Re: Response to Council's 2nd Request for Information dated 17 October 2025 in relation to DA 298/2025 at 3 Redmond Place, Orange

COUNCIL'S REQUEST FOR INFORMATION DATED 19 SEPTEMBER 2025

Road 4 – Please refer to above.

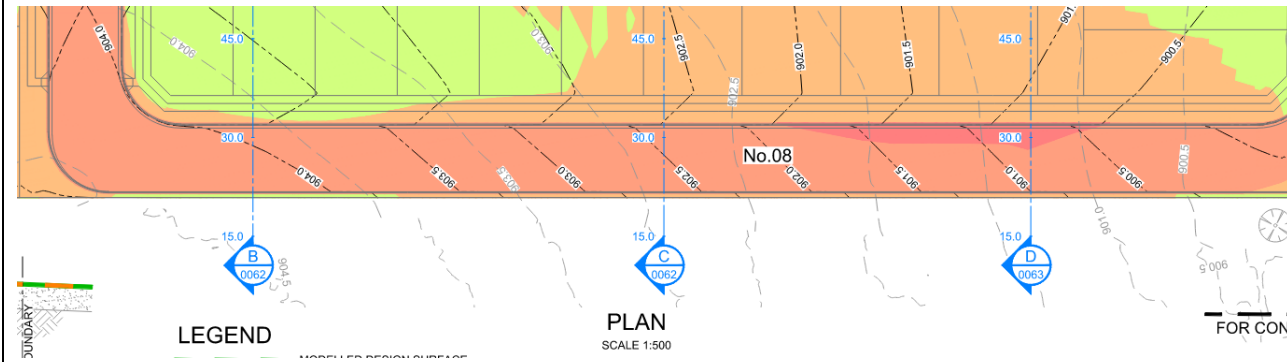
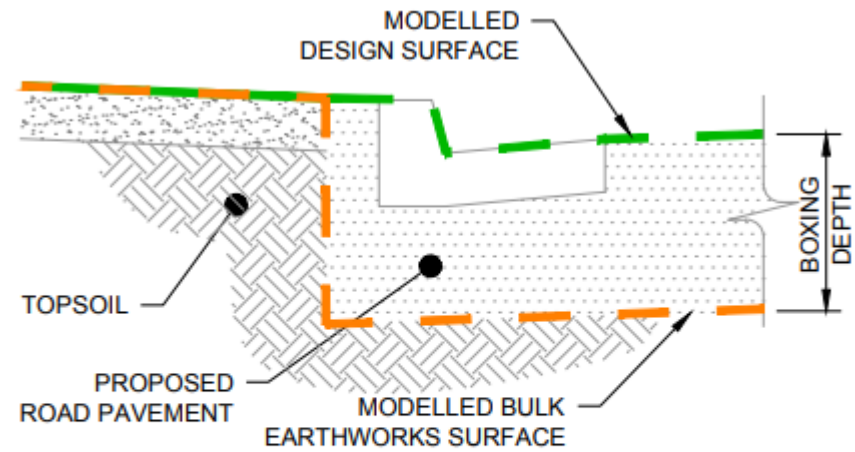
- Significant level differences between the development and neighbouring land along the common boundary of the proposed 'Interface Street' – roads 4, 7 and 8.

PLAN 'A'
SCALE 1:250

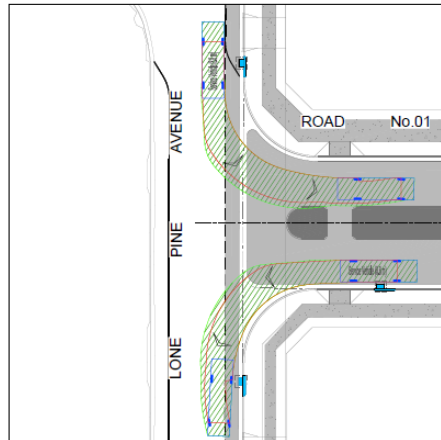
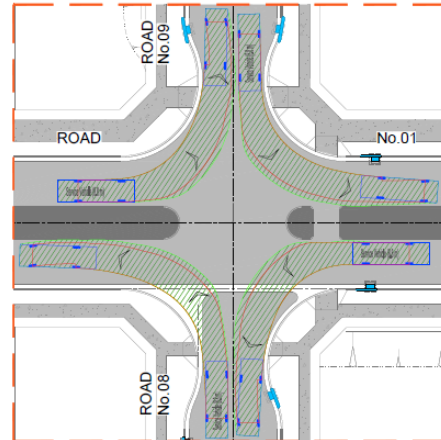
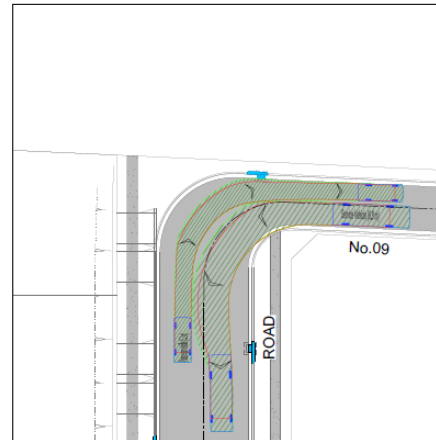
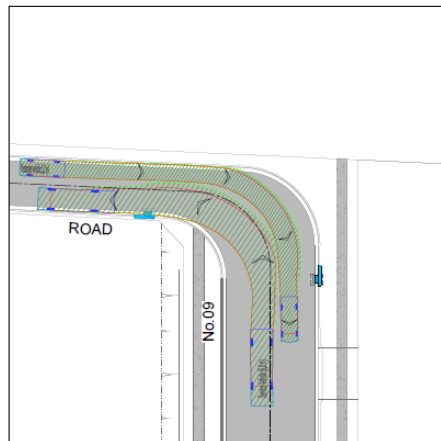
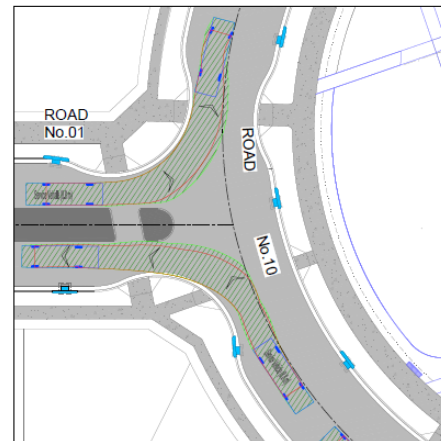
- The swept path analysis needs to demonstrate that a 12.5m heavy rigid vehicle (garbage truck / fire appliance) as used by local waste contractors can manoeuvre through the intersections. Please include clearances on both sides of vehicle.
- 10/11/2025 Response- HRV swept paths with clearance lines are added on swept paths provided in the updated civil plans.

Figure 10 Water Demand allowance per lot size

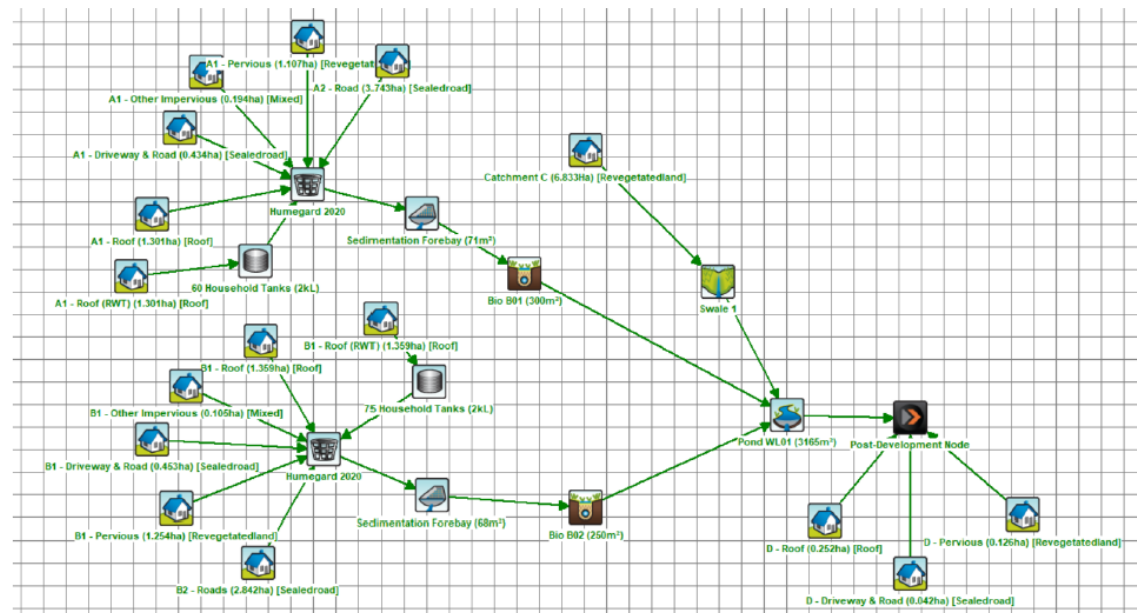
- Can you confirm that NorBE is achieved in the MUSIC model without the need for 1725 kL/yr re-use from the storage pond? Stormwater re-use is not being proposed by OCC.
- 10/11/2025 Response- It is confirmed that NorBE is achieved in the MUSIC model without the need for 1725 kL/yr re-use from the storage pond. Please refer updated MUSIC model and Water Cycle Management Report.

The stormwater treatment is supplemented by a total of 135 2kL rainwater tanks distributed between low density lots within the northern and southern precincts for rainwater harvesting and re-use for internal usage such as toilet flushing, car washing, general wash down and irrigation. Furthermore, re-use from the storage pond for additional irrigation or other purposes have been allowed for with an annual demand of 1725 kL/yr as PET-rain. In the absence of water reuse rates in the Orange City Council guidelines, the Blacktown City Council WSUD Developer Handbook (2020) Section 11.14.3 Non-potable reuse rates for modelling reuse tanks in MUSIC have outlined the demand rates that was used in MUSIC for modelling purposes to ensure that demand can be met. See Figure 10.
